Caroline Thomas Jacobs, Director
Office of Energy Infrastructure Safety
California Natural Resources Agency
Sacramento, CA 95184
efiling@energysafety.ca.gov

Subject: Comments of the Public Advocates Office on PG&E's 2025 Wildfire Mitigation Plan Update

Docket: 2023-2025-WMPs

Figure 1:
Wildfire risk associated with PG&E’s riskiest 10,000 circuit miles¹¹

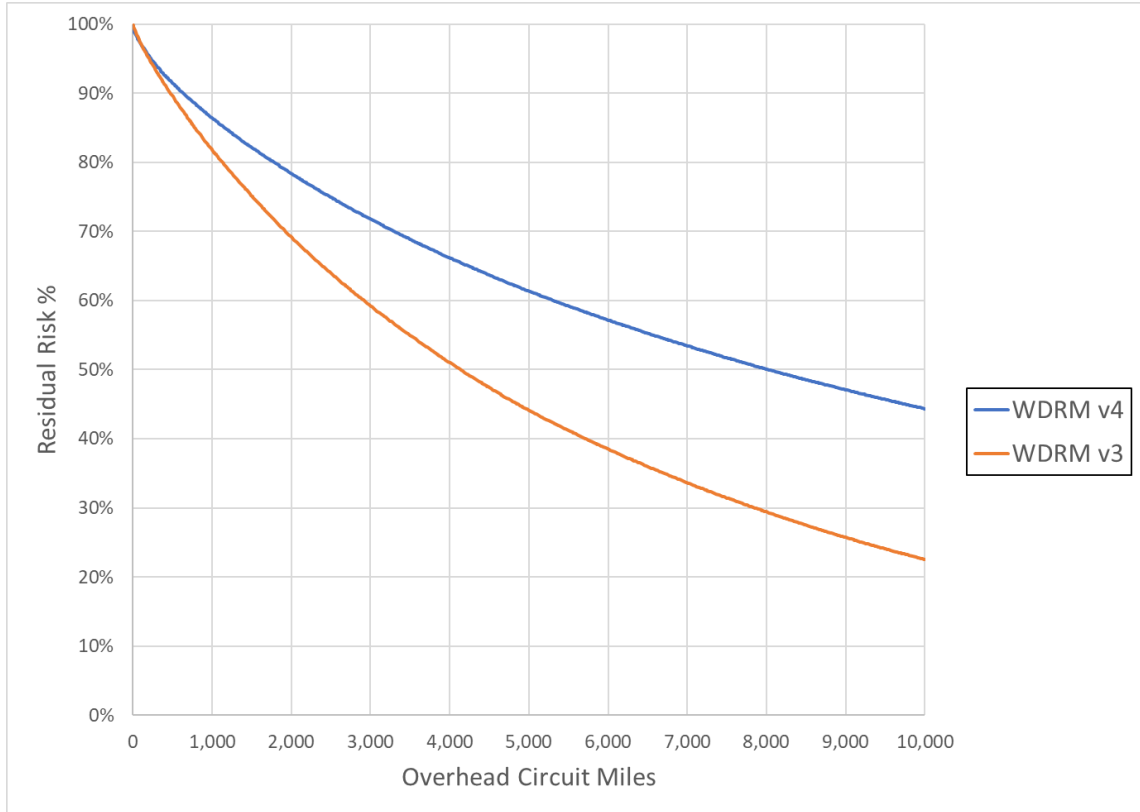
PG&E's WDRM v4 shows less concentrated wildfire risk in PG&E's system compared to WDRM v3.⁸ PG&E's WDRM v3 estimated that the riskiest 10,000 circuit miles in PG&E's system carried approximately 78 percent of PG&E's total wildfire risk.⁹ Under WDRM v4, the same number of miles carries only 56 percent of PG&E's total wildfire risk.¹⁰ Figure 1 illustrates this difference.

Figure 1 shows overhead circuit-mileage on the X-axis, organized sequentially from most to least risky. On the Y-axis, it shows the percentage of wildfire risk remaining. The curves represent what would happen if PG&E hardened its overhead circuit-miles in the HFTD in sequential fashion, starting with the riskiest miles – the “risk buydown curve.” Notably, the curve for WDRM v4 (in blue) declines much more gradually, meaning that it takes more

Furthermore, PG&E's newest risk model shows that risk is less concentrated than previously thought (see Figure 1). Under WDRM v4, if PG&E were to underground its riskiest 8,000 miles, it would eliminate only 49 percent of the total wildfire risk in its system.³⁸ It is not clear to what extent WDRM v4 represents a *redistribution* of risk as opposed to capturing *additional* risk that was not quantified in the previous version.³⁹ Regardless, the practical effect

**Figure 2:
WDRM risk ranking of circuit segments in the HFTD¹⁹**

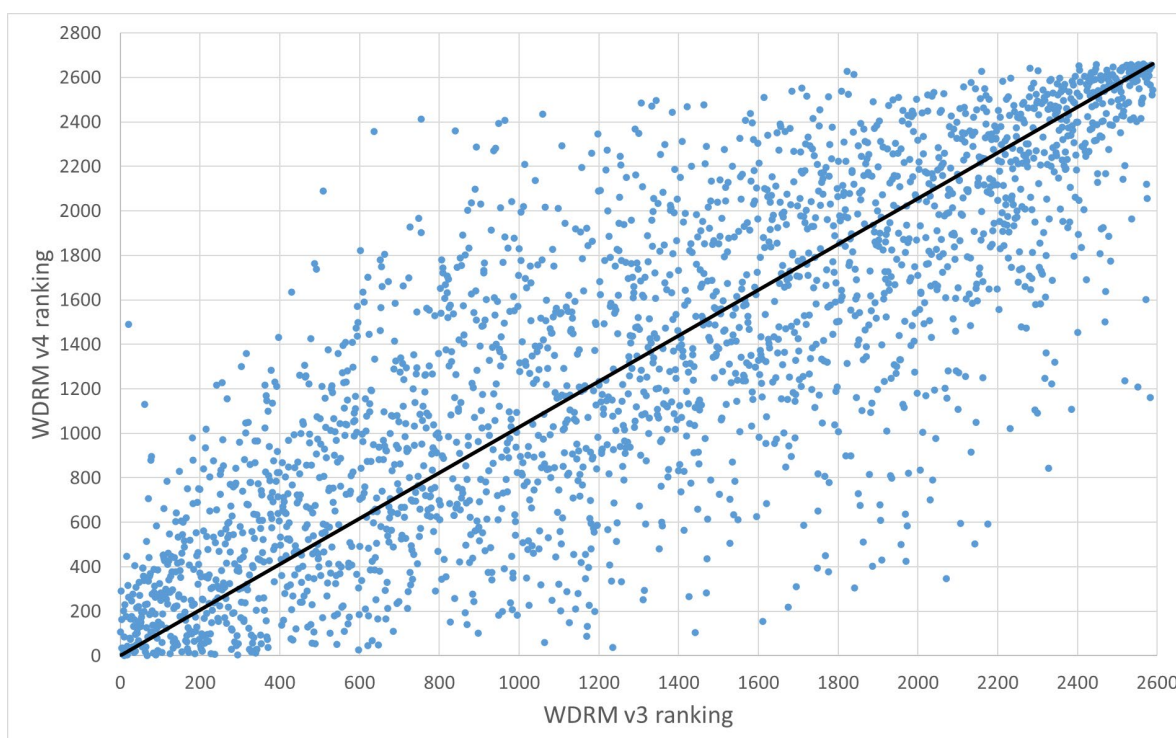
In addition to a flatter risk buydown curve, WDRM v4 redefines the circuit segments that are considered the highest risk. Figure 2 plots the risk ranking for circuit segments in the high fire-threat districts (HFTD) under both versions of the model.

Figure 2 shows the risk rankings for PG&E’s circuit segments in the HFTD under the current and prior versions of the WDRM. Lower rankings indicate high risk, while higher

rankings indicate comparatively lower risk. Although there is an undeniable correlation between the models, many circuit segments that were considered high risk under WDRM v3 are ranked lower under WDRM v4, and vice versa. This reversal has happened before, when PG&E updated its WDRM from version 1 to 2, and again from version 2 to 3.²⁰ These frequent changes of relative risk call into question the reliability of the risk model results, especially when used to plan undergrounding projects that take several years to execute.

PG&E has updated its wildfire risk model every one to two years since 2019.⁶⁶ As shown in Figure 2, the newest version of PG&E's risk model substantially shifts the risk ranking of circuit segments. Cal Advocates has previously noted this to be true of all previous versions as well.⁶⁷ These frequent and substantial changes do not support a wildfire mitigation strategy that relies on slow and costly methods such as undergrounding. Undergrounding, by its nature, lags substantially behind risk assessment maturity. For example, in 2026 PG&E expects that it will still be completing undergrounding projects that are based on WDRM v2 – a model developed in 2021 with data inputs that end in 2018-2020.⁶⁸
